The Commission has issued the enclosed Amendments Nos. 34, 34 and 31 for Licenses Nos. DPR-38, DPR-47 DPR-55 for the Oconee Nuclear Station, Units Nos. 1, 2 and 3. These amendments consist of changes to the station Technical Speicifications and are in response to your request dated July 21, 1976, as supplemented August 28, October 7, October 19, October 20, and October 20, 1976.

DUKE POWER COMPANY

OCONEE NUCLEAR STATION, UNIT 1

Amendment No. 34
License No. DPR-38

Figure 3.5.2-3C1

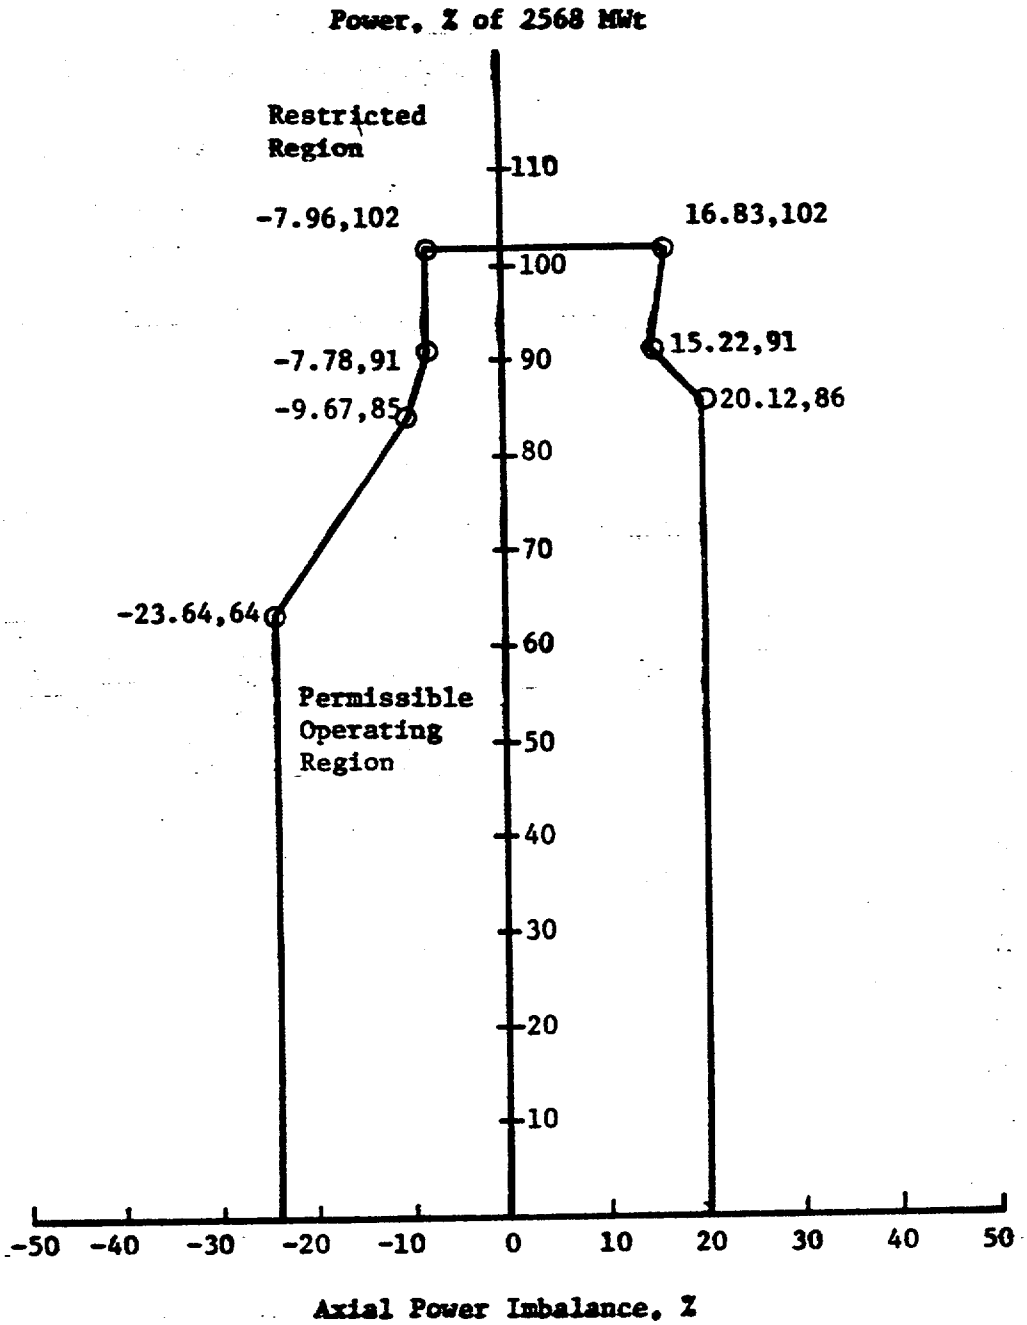
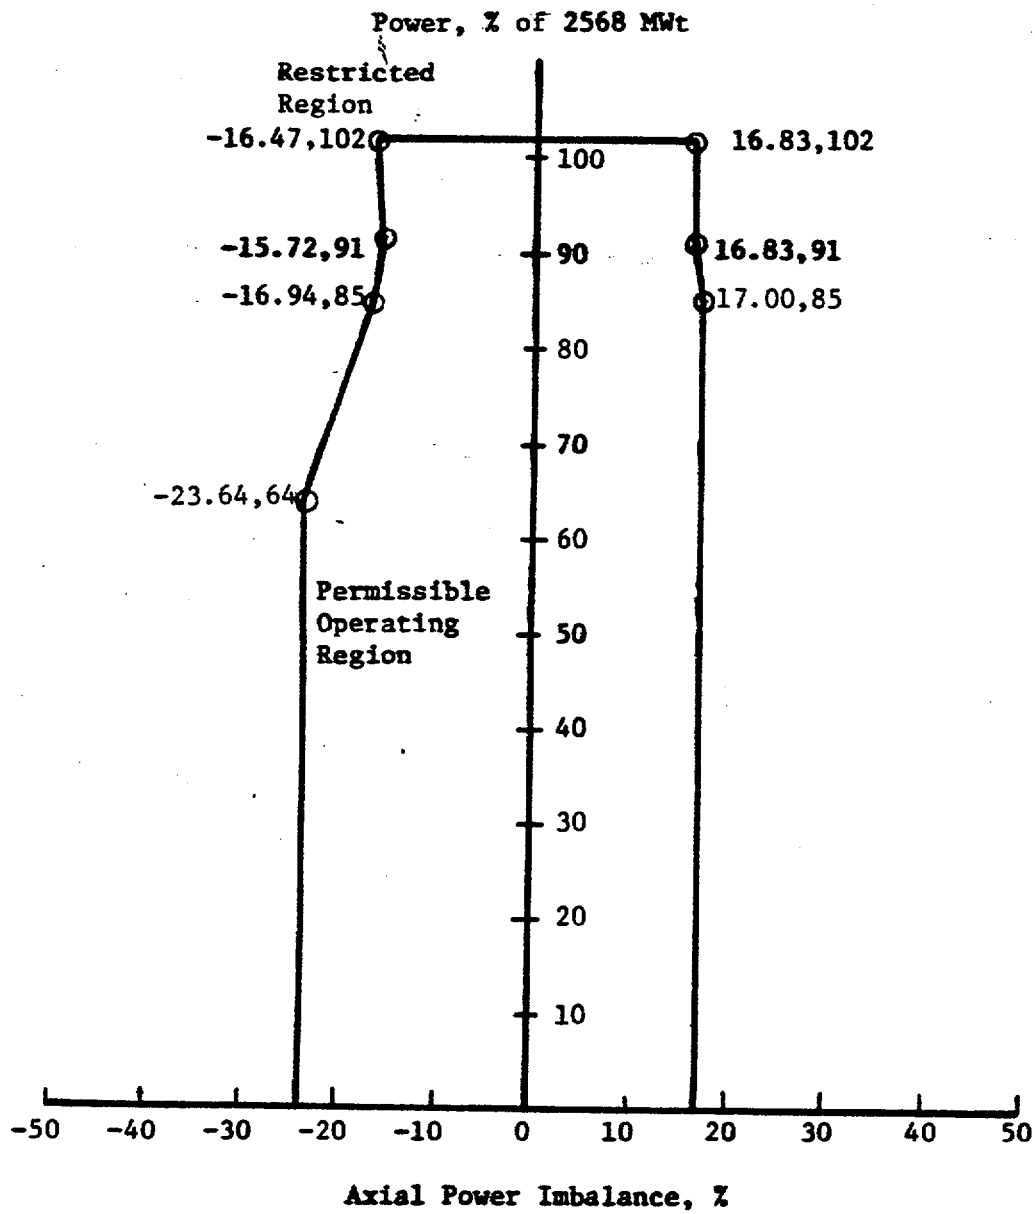
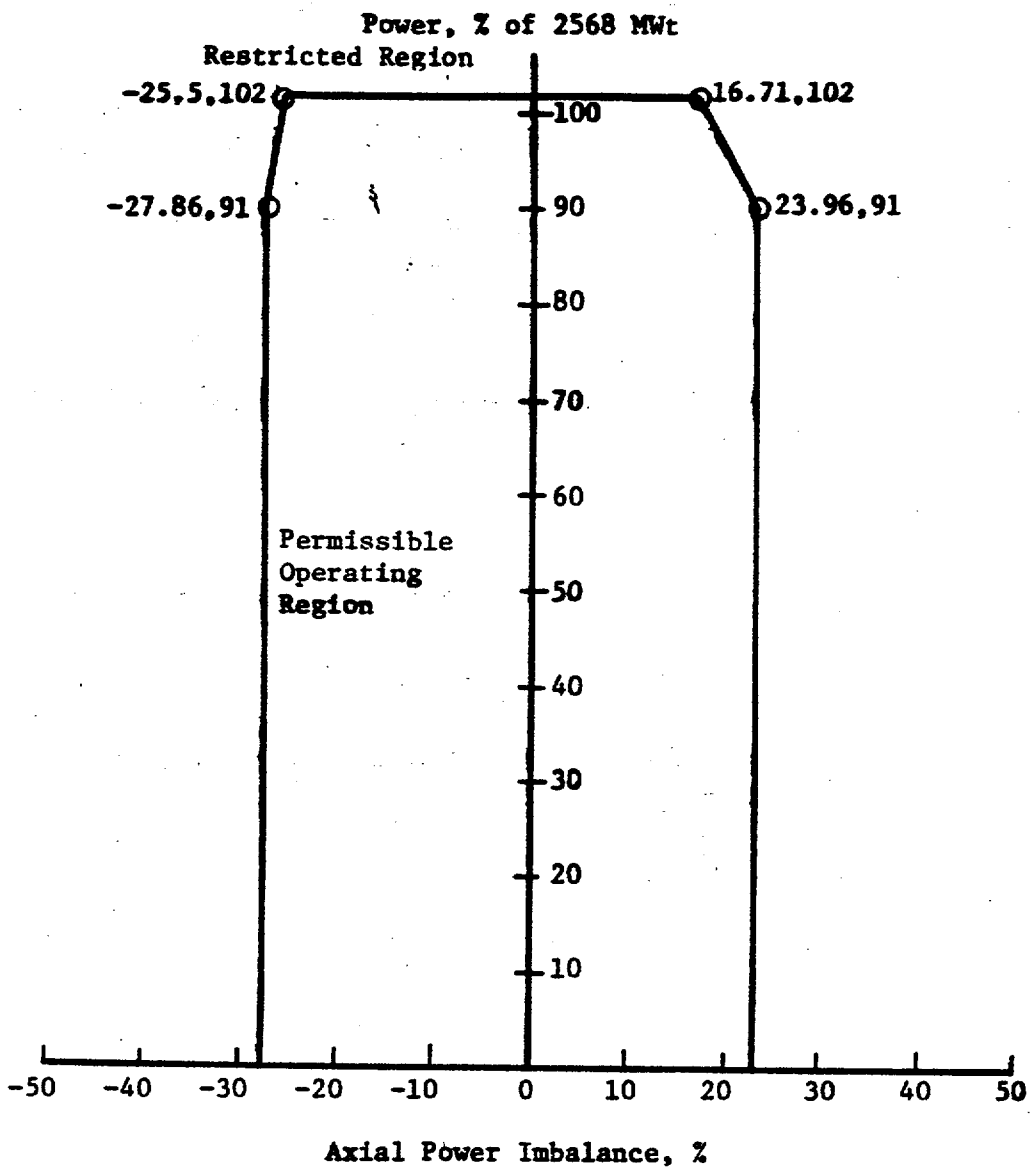
The power-imbalance envelope defined in Figures 3.5.2-3A1, 3.5.2-3A2, 3.5.2-3B1, 3.5.2-3B2, 3.5.2-3B3, 3.5.2-3C1, 3.5.2-3C2 and 3.5.2-3C3 is based on LOCA analyses which have defined the maximum linear heat rate (See Figure 3.5.2-4) such that the maximum clad temperature will not exceed the Final Acceptance Criteria. Corrective measures will be taken immediately should the indicated quadrant tilt, rod position, or imbalance be outside their specified boundary. Operation in a situation that would cause the Final Acceptance Criteria to be approached should a LOCA occur is highly improbable because all of the power distribution parameters (quadrant tilt, rod position, and imbalance) must be at their limits while simultaneously all other engineering and uncertainty factors are also at their limits.** Conservatism is introduced by application of:
